Docket No. 50-333

The Commission has issued the enclosed Amendment No. 43 to Facility Operating License No. DPR-59 for the James A. FitzPatrick Nuclear Power Plant. The amendment consists of changes to the Technical Specifications in response to your reload application submitted by letter dated August 18, 1978.

AMENDMENT TO FACILITY OPERATING LICENSE

Amendment No. 43
License No. DPR-59

FIGURE 1.1-1 APRM FLOW BIAS SCRAM RELATIONSHIP TO NORMAL OPERATING CONDITIONS

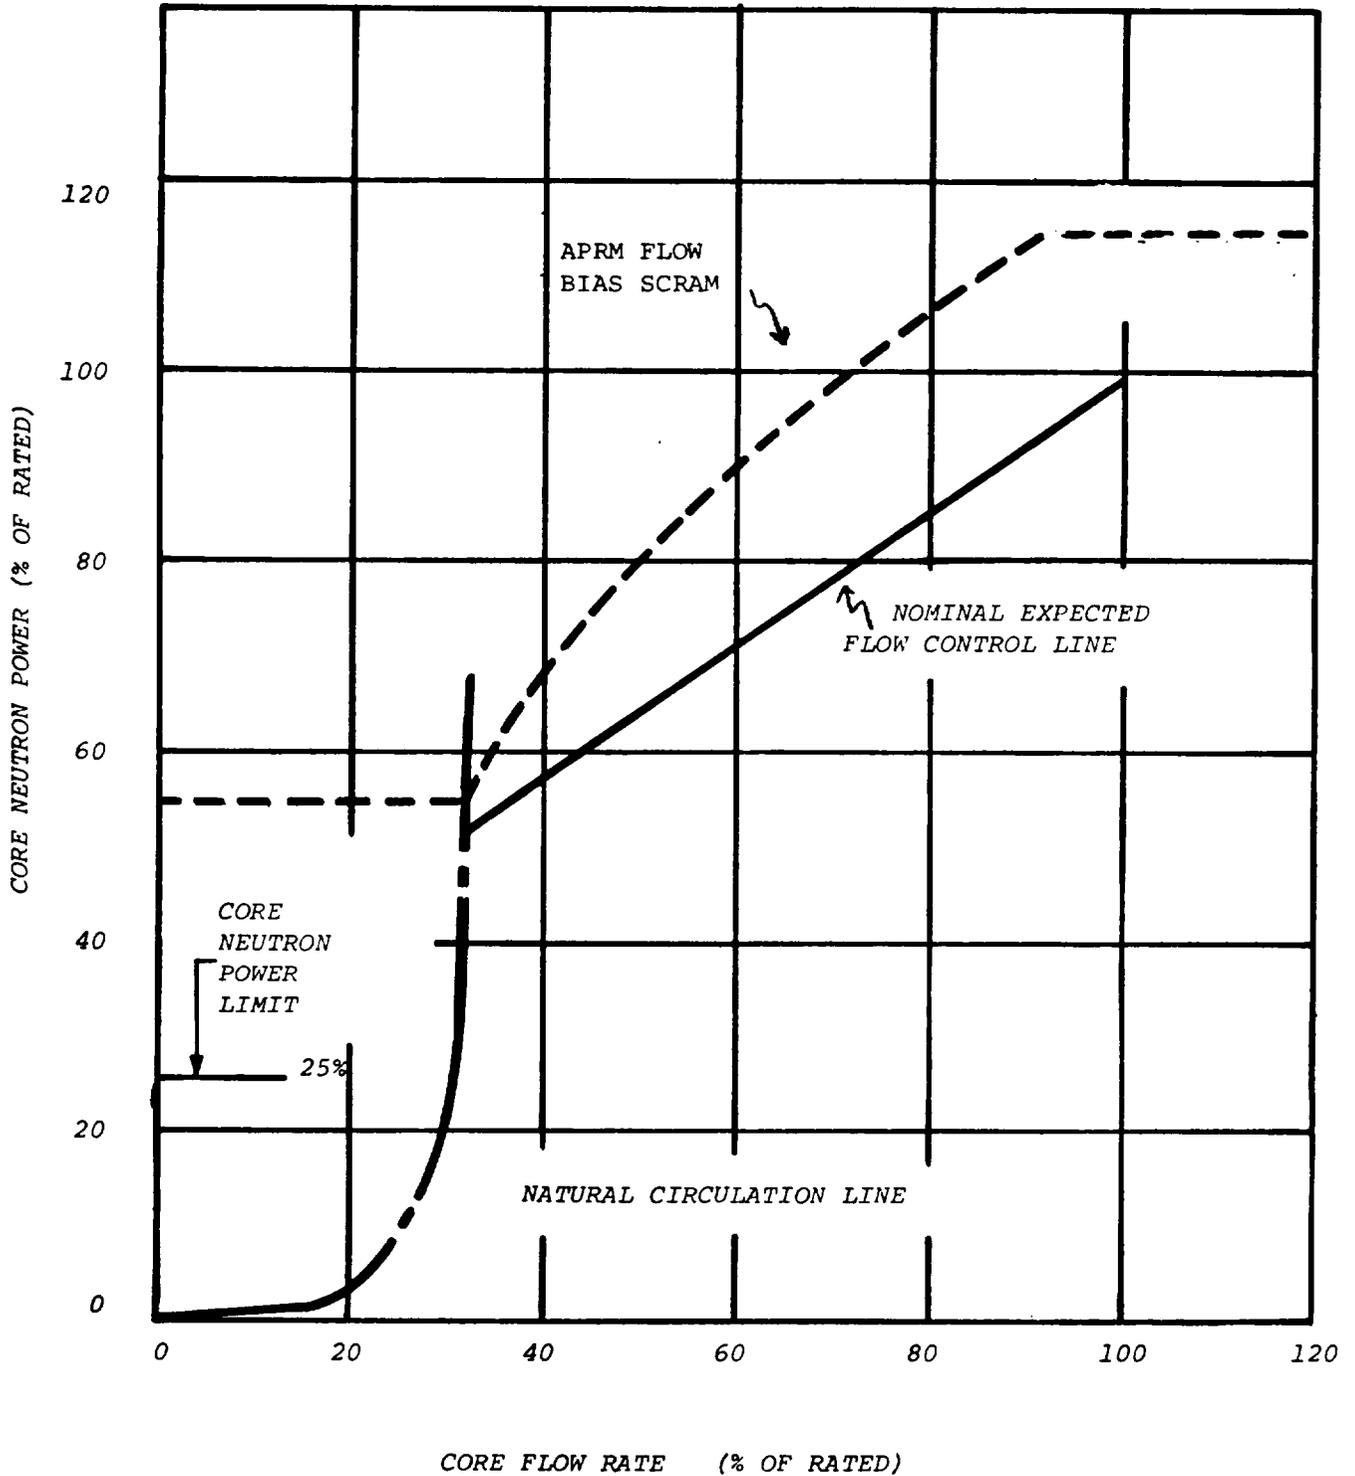
c. APRM Flux Scram Trip Settings (Run Mode)(1) Flow Referenced Neutron Flux Scram Trip Setting

When the Mode Switch is in the RUN position, the APRM flow referenced flux scram trip setting shall be:

$$S \leq 0.66 W + 54\%$$

For no combination of loop recirculation flow rate and core thermal power shall the APRM flux scram trip setting be allowed to exceed 117% of rated thermal power.

13. The Average Power Range Monitor scram function is varied (Figure 1.1-1) as a function of recirculation loop flow (W). The trip setting of this function must be maintained in accordance with Specification 2.1.A.1.c.

FIGURE 3.5-5 MAXIMUM AVERAGE PLANAR LINEAR HEAT GENERATION RATE (MAPLHGR) VERSUS PLANAR AVERAGE EXPOSURE

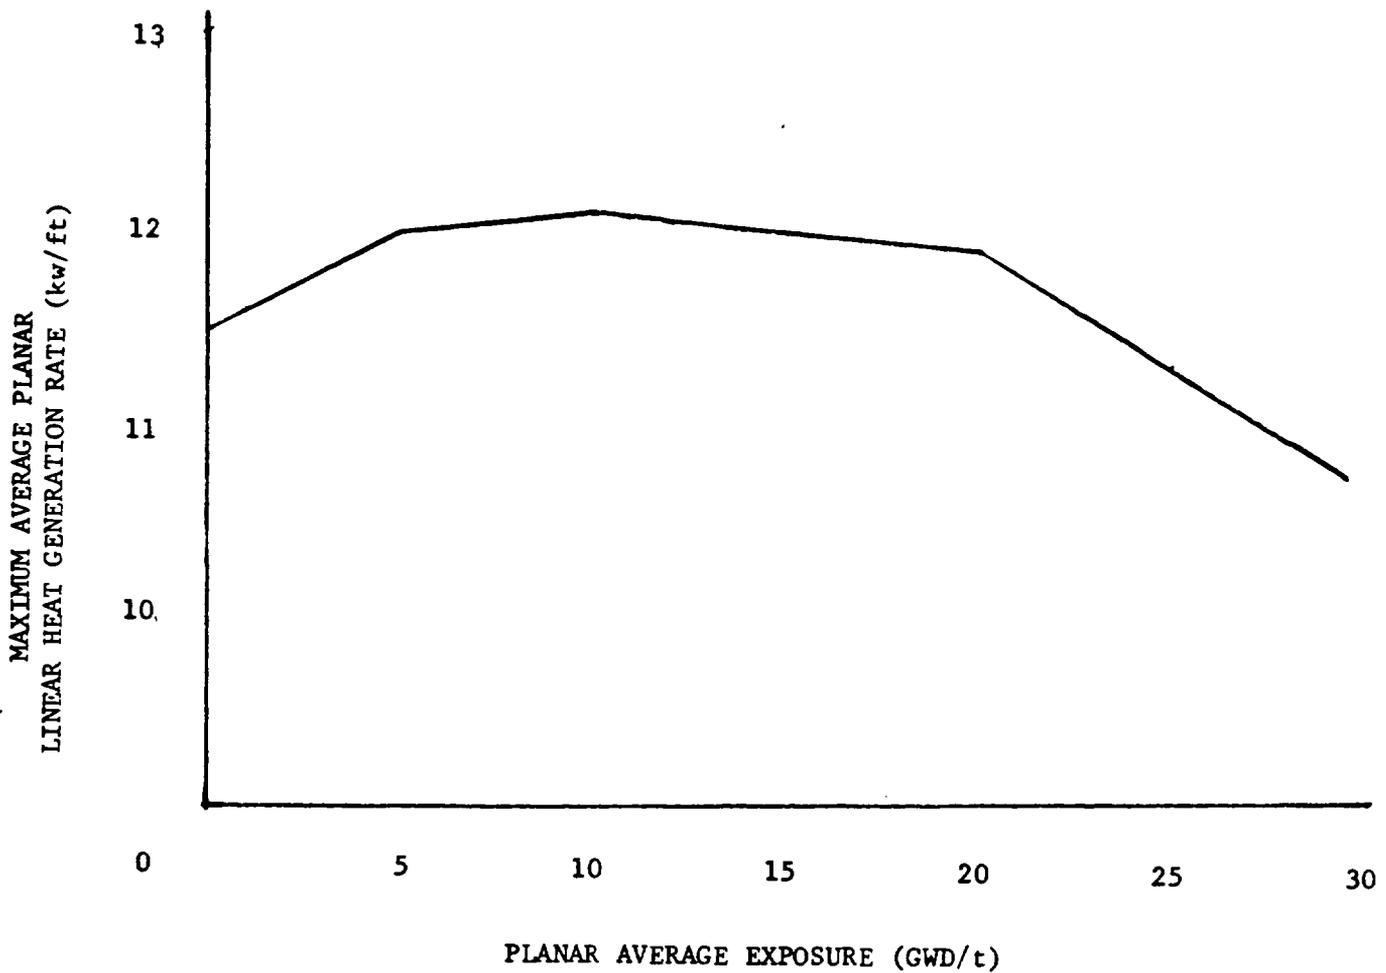
The APLHGR for each type of fuel as a function of average planar exposure shall not exceed the limiting value shown in Figures 3.5.1 through 3.5.6. If anytime during reactor power operation greater than 25% of rated power it is determined that the limiting value for APLHGR is being exceeded, action shall then be initiated within 15 minutes to restore operation to within the prescribed limits. If the APLHGR is not returned to within the prescribed limits within two (2) hours, an orderly reactor power reduction shall be commenced immediately. The reactor power shall be reduced to less than 25% of rated power within the next four hours, or until the APLHGR is returned to within the prescribed limits.

are within the 10 CFR 50 Appendix K limit. The limiting value for APLHGR is shown in Figure 3.5.1 through 3.5-6.
